Village of Lincolnwood Plan Commission

SUBJECT: Plan Commission Workshop – Review Revised Purple Hotel Concept Plans

Community Development Department Review

Project: 4500 West Touhy
Purple Hotel Property
Conceptual Plan Landscape Review
Lincolnwood, Illinois
Land Design Collaborative, Inc.

East Alcove between Building #1 and #3

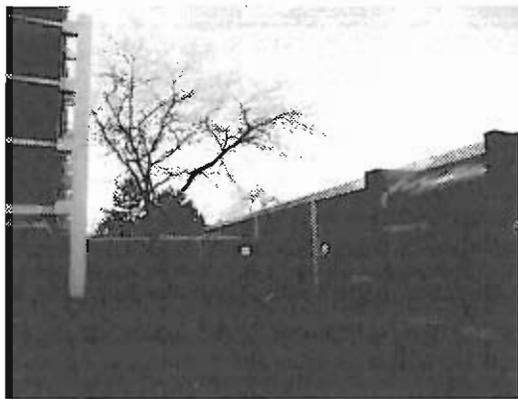
- “For aesthetic and safety/security reasons to avoid an entrapment potential near the dumpsters a decorative, lockable gate should be considered.”
- “Pedestrian access is unclear between building #1 and Buildings #2 and #3. Will the building entries be located in this area? Will these entries require access codes or cards? The areas between the buildings need to be well lighted and safe with exits to prevent “trapping” of unaware pedestrians.”

East Side of Dumpster Area at Stairway

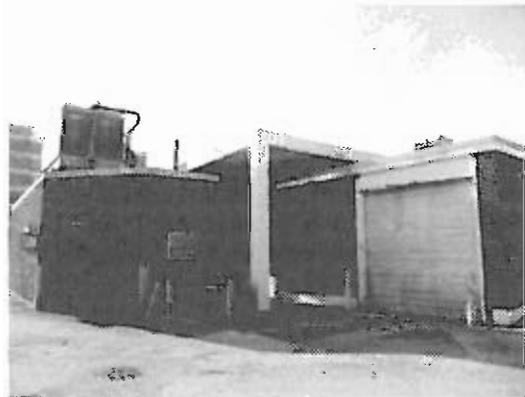
- The dumpster bay and the east side stairway at the dumpster area are potential entrapment places and need to be lighted and secured.

DRAWING NO.
PUD-01

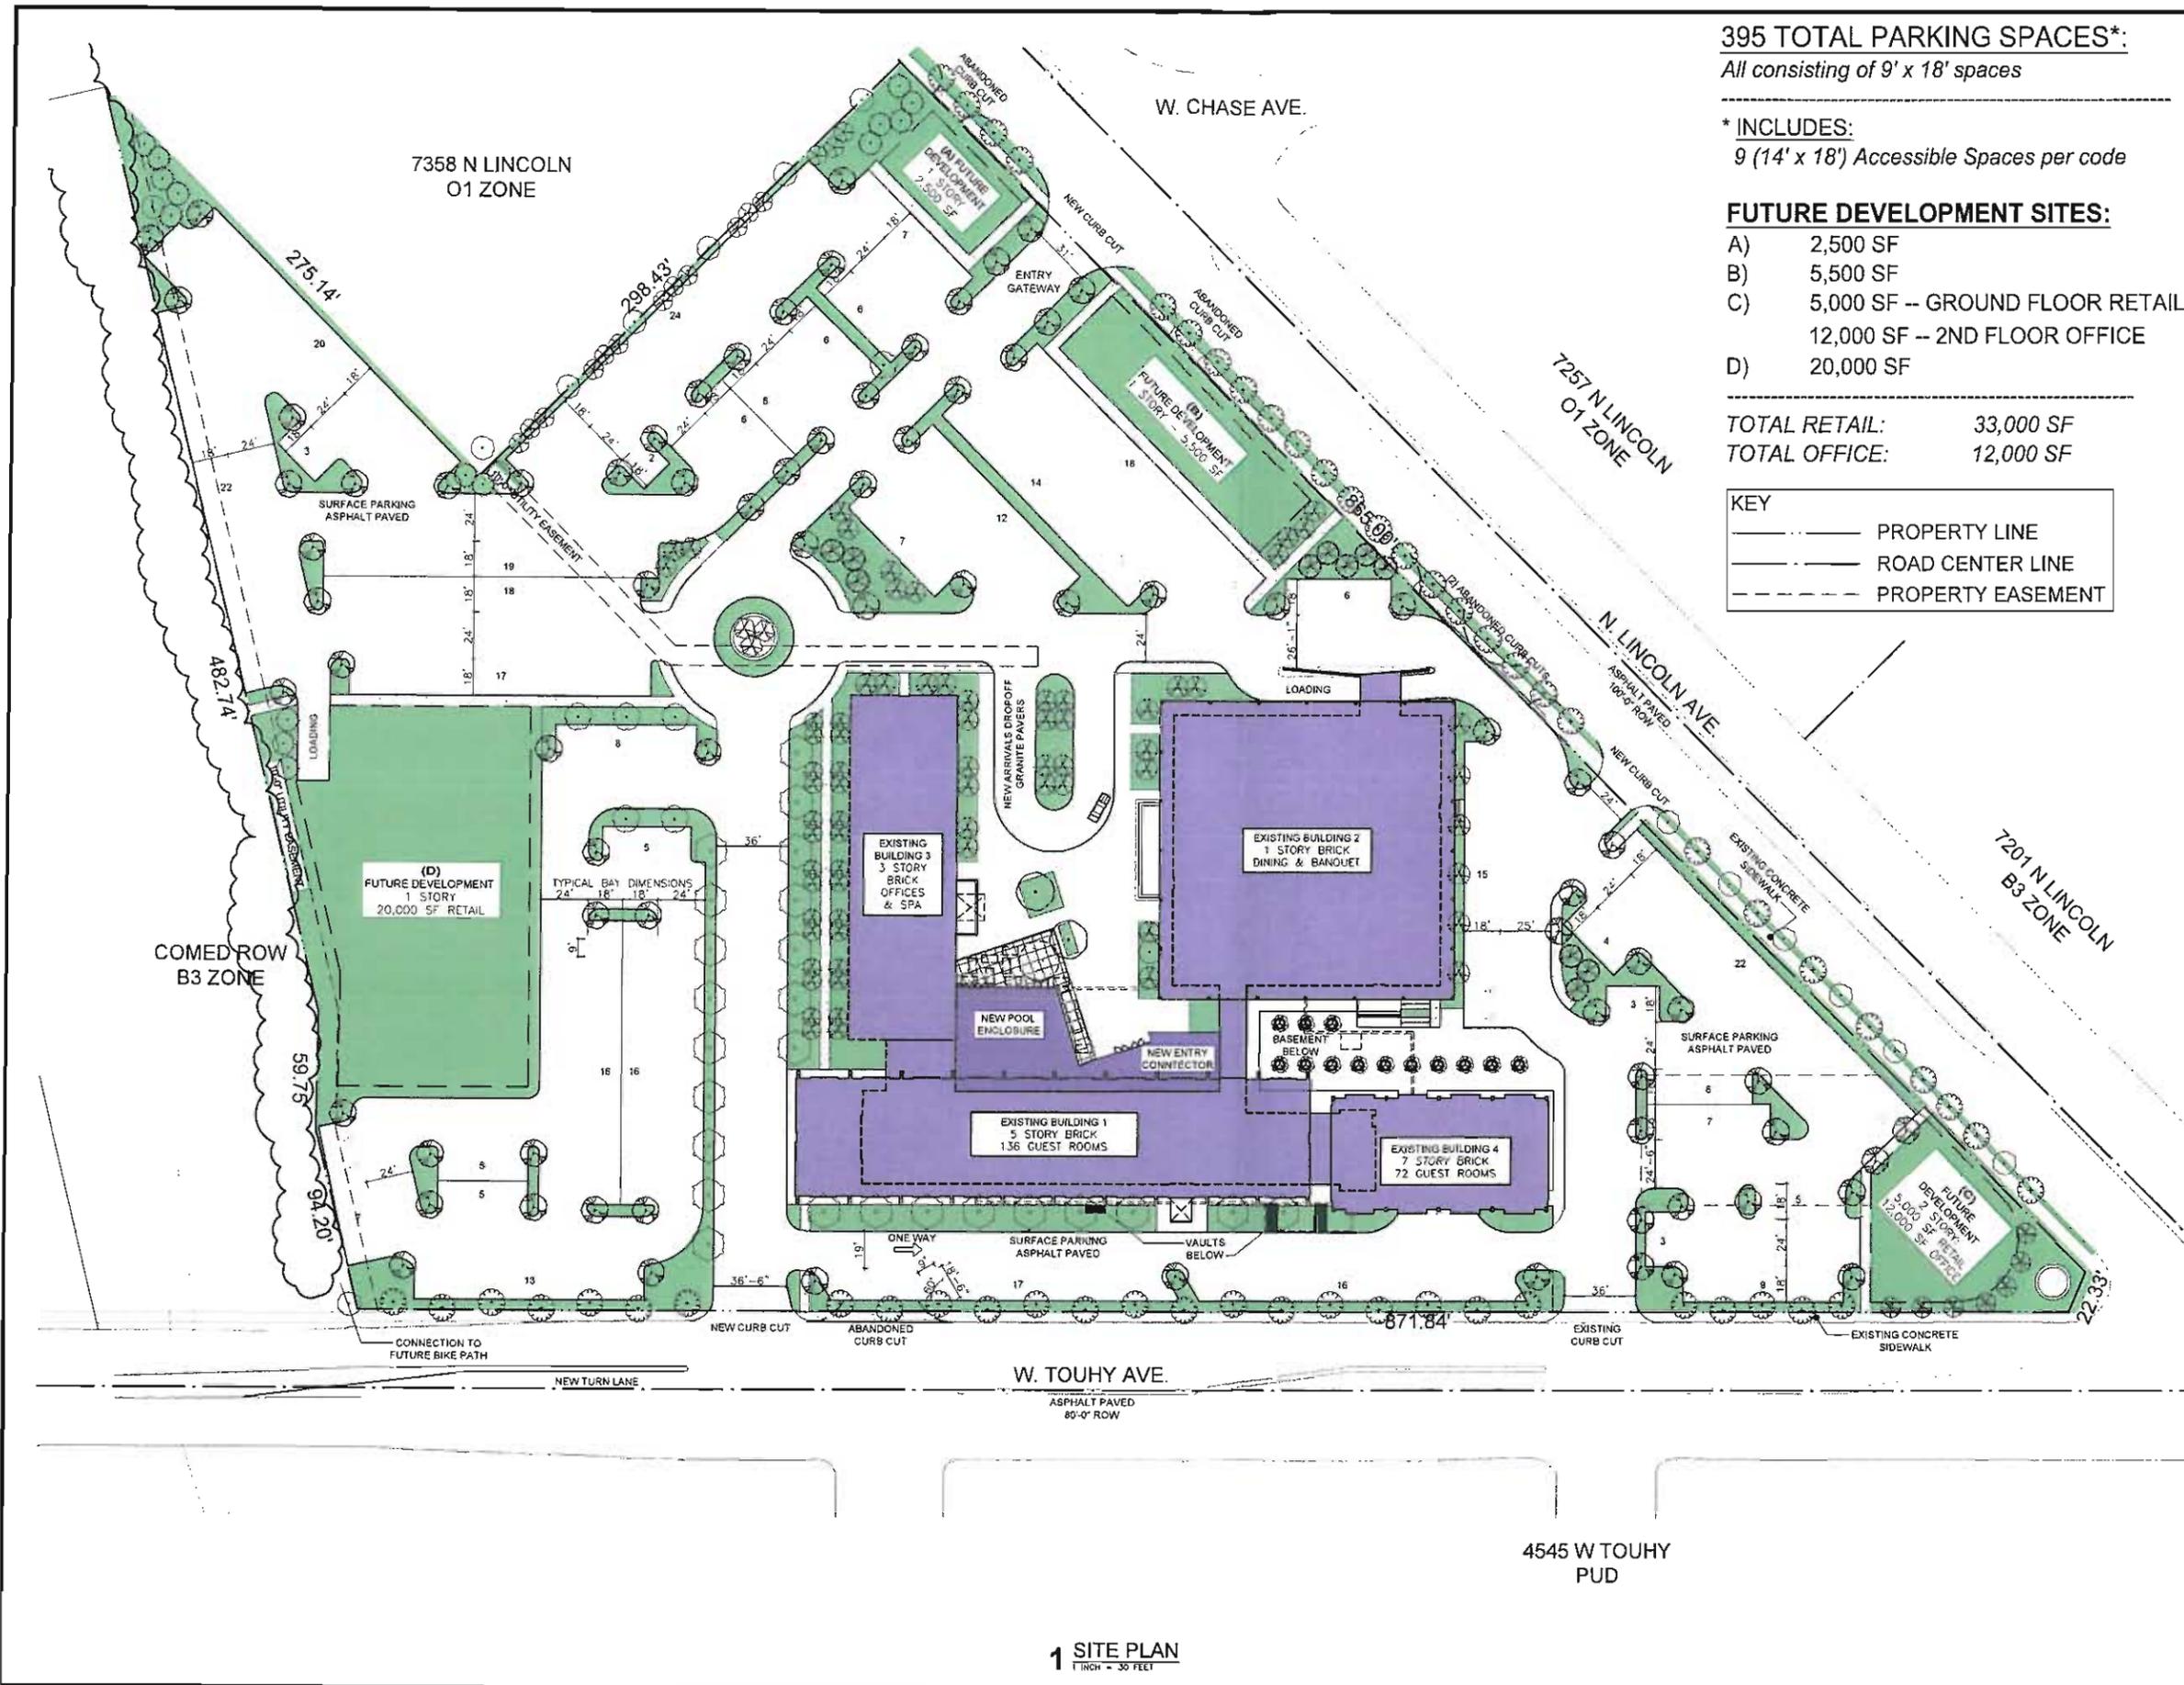
Driveway Paralleling Touhy Avenue: This is proposed as one-way eastbound. The Fire Department desires this driveway to be either two way or one way west bound. If was further indicated that passengers exiting taxi cabs would be best served with a one-way westbound driveway.

- ❖ The revised plans indicate a relocated Touhy Avenue curb cut and two new curb cuts on Lincoln Avenue. IDOT approval of these new and relocated curb cuts should be provided.
- ❖ Dimensions for all landscape areas need to be provided.
- ❖ A timeline for development of the new buildings on the site should be provided.
- ❖ The Developer estimates of parking demand, which include reductions to parking demand taken to account for shared parking among uses, indicate that a peak parking demand of 440 parking spaces would result but only 395 parking spaces would be provided on the property. It is not clear from the study provided what parking demand factor was used for the new development areas. Staff notes that restaurants and entertainment venues typically require higher parking requirements than general retail

NOTE: The one new item we would like to see changed is the traffic flow pattern of the south drive along Touhy Avenue as any arriving fire department vehicles may be using this drive. Especially in the case of an arriving ambulance traffic will not be able to clear the drive by “pulling forward” so the ambulance can gain access, but rather would be blocked in or need to back-up to clear the drive for the fire department vehicles. The proposed direction change goes against the natural flow of traffic for arriving vehicles which would have a difficult time making a “U-Turn” to access the drive as proposed.

DRAWING NO
L-01

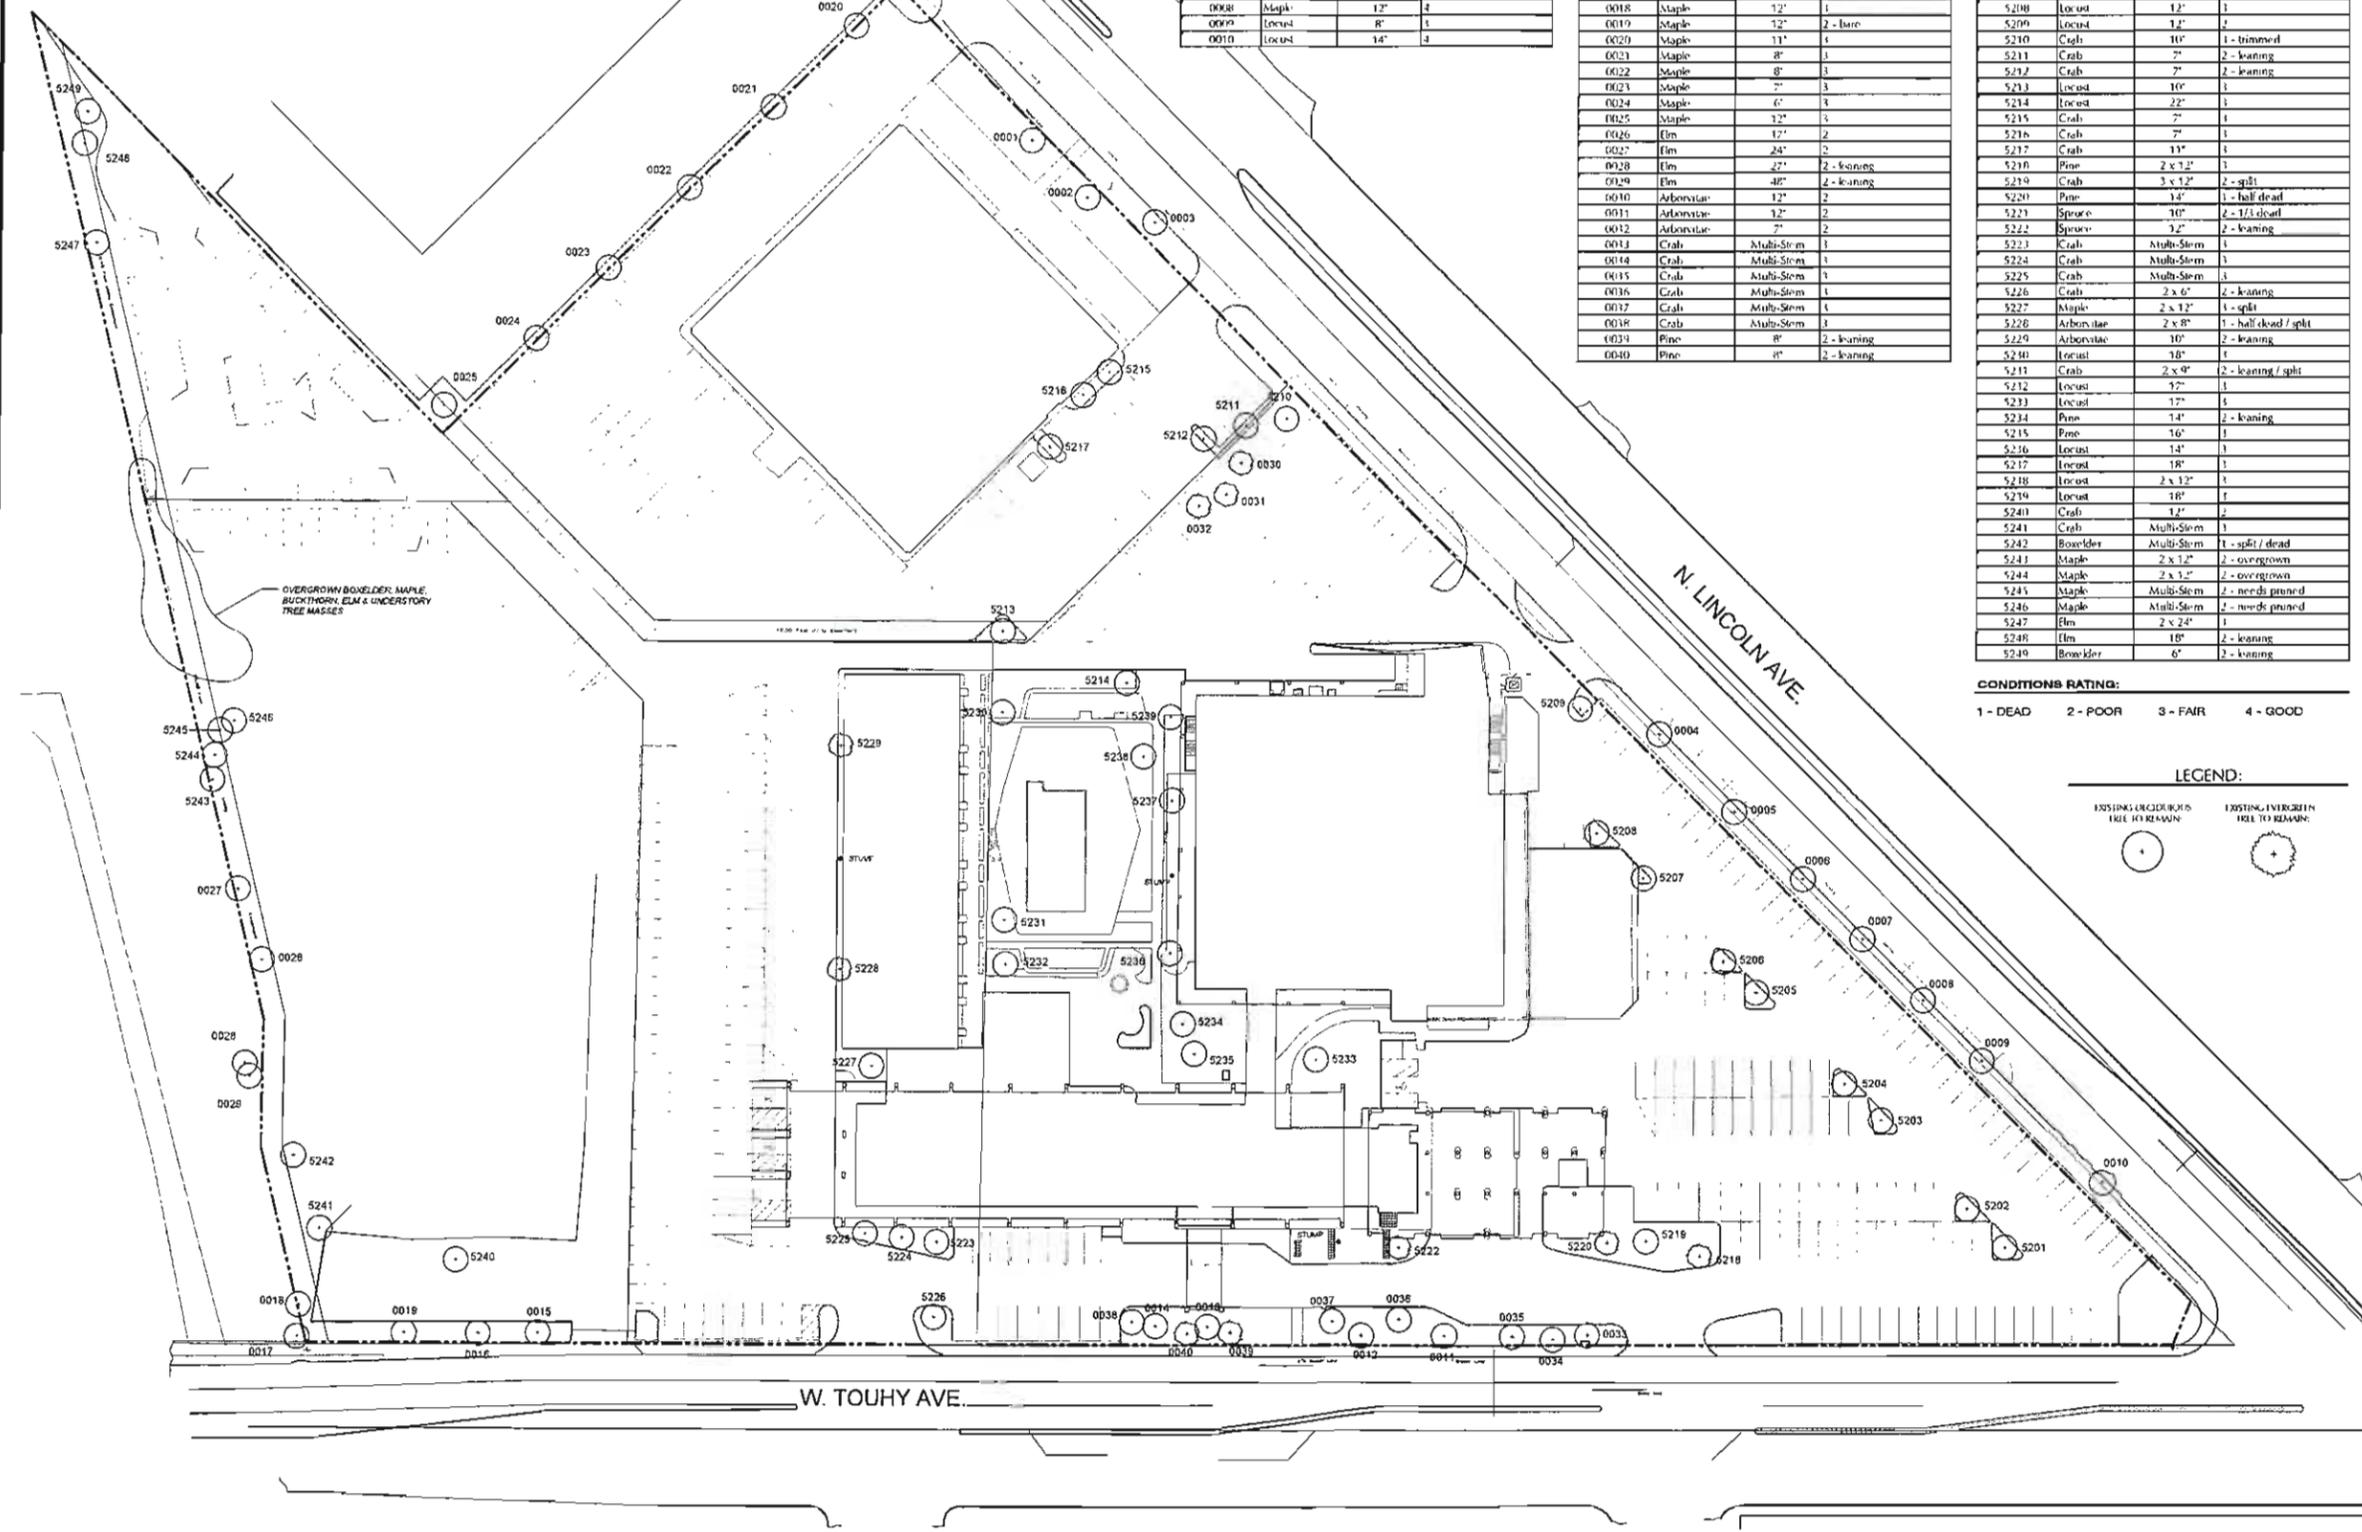
- ❖ Trees indicated to remain on the Site Tree Inventory do not appear to align with the proposed landscape/site plan. (legend wrong?)
- ❖ It appears from narrative provided that Storm Water detention has not yet been designed for any of the new buildings proposed for the site. Staff notes that the Town Center PUD provided all storm water detention in the first phase of that development. Staff recommends that total storm water determination for the development as proposed be provided, detention locations indicated and detention installed as part of the initial improvements planned for the PUD.
